BOROUGH OF OCEANPORT

AGENDA • SEPTEMBER 12, 2023

1. PB2023-13 Monmouth Park / MBD Development LLC

Re: **NJSEA Site Plan Submission**
Monmouth Park
Proposed Mixed Use Project

A-01
SITE PLAN
20-1005-01
COPYRIGHT © MINNO & WASKO ARCHITECTS AND PLANNERS

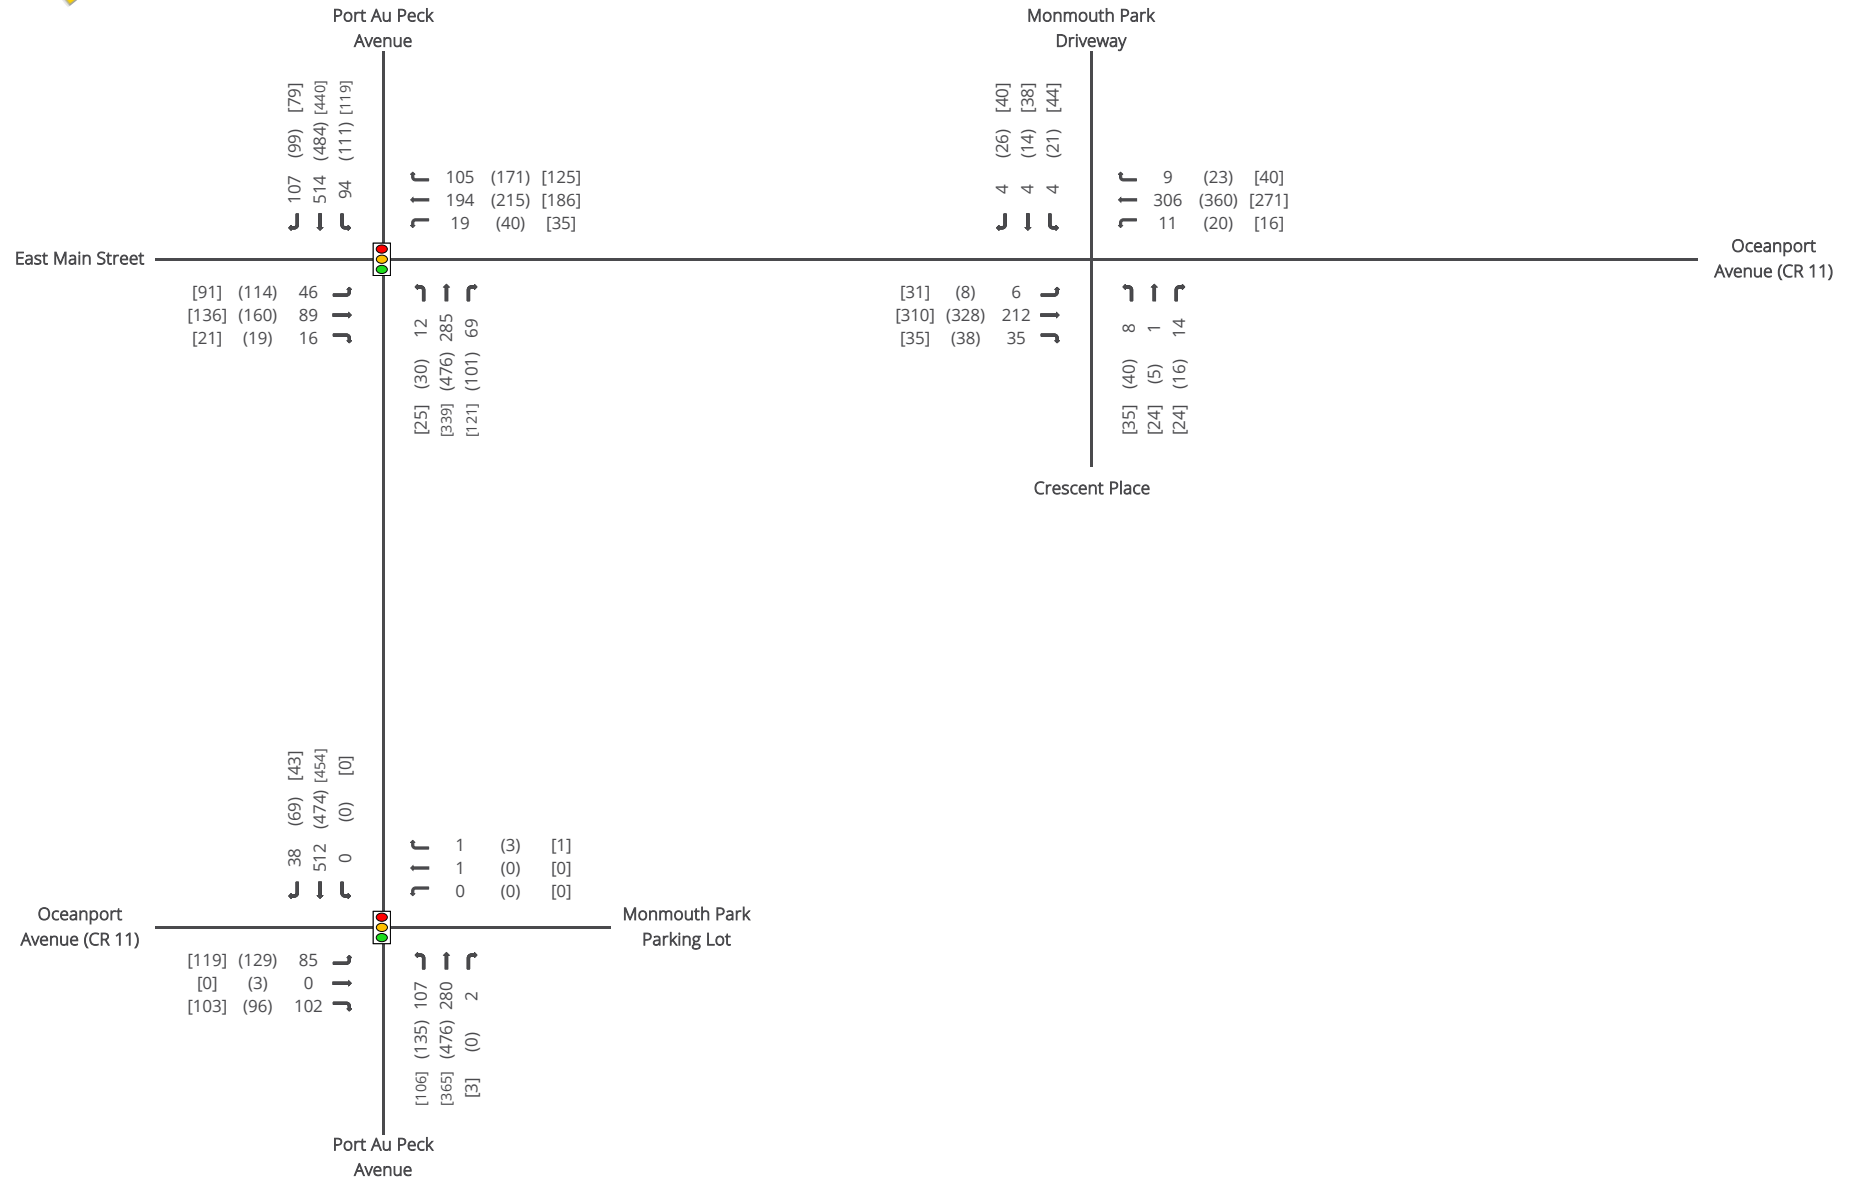
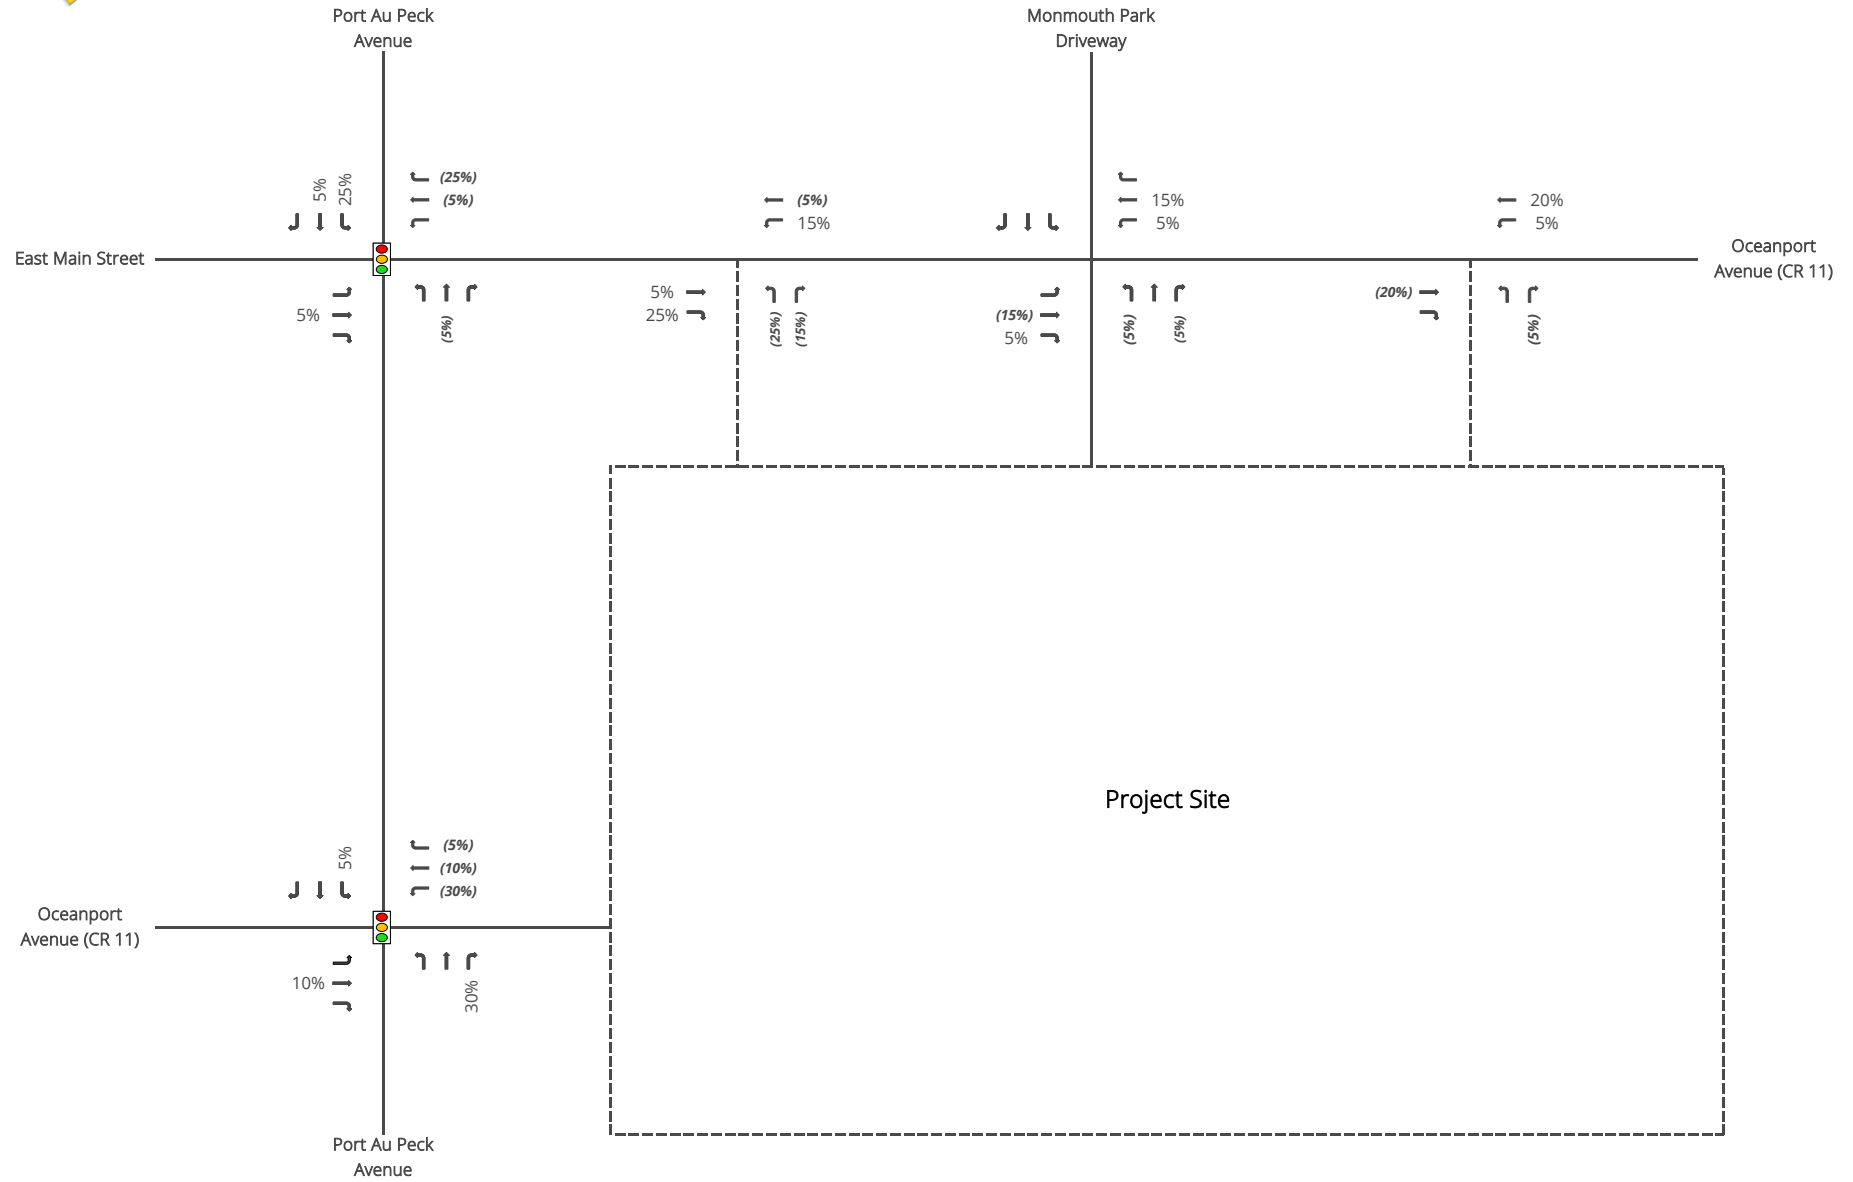
OCEANPORT COMMENT: The tot lot and dog park are located very close to the intersection of Port-Au-Peck Avenue and Oceanport Avenue. These amenities should be relocated away from this busy intersection and more centrally located so that all residents have easy access to them.

OCEANPORT COMMENT: Given the proximity of existing residential neighborhoods and public open space to proposed development, the building and parking improvements should be located outside of a 100-foot buffer. A planted buffer should be provided as a screen of the proposed development from any adjacent residential or public open space area to adequately protect the quality of life for the existing residents and users of the public open space.

RESPONSE: The plans have been revised so that the play area is now near the tennis court. The dog run has been relocated to the southeast corner of the site.

RESPONSE: The plans include significant buffering including undulating berms and dense landscaping around the entire perimeter of the site.
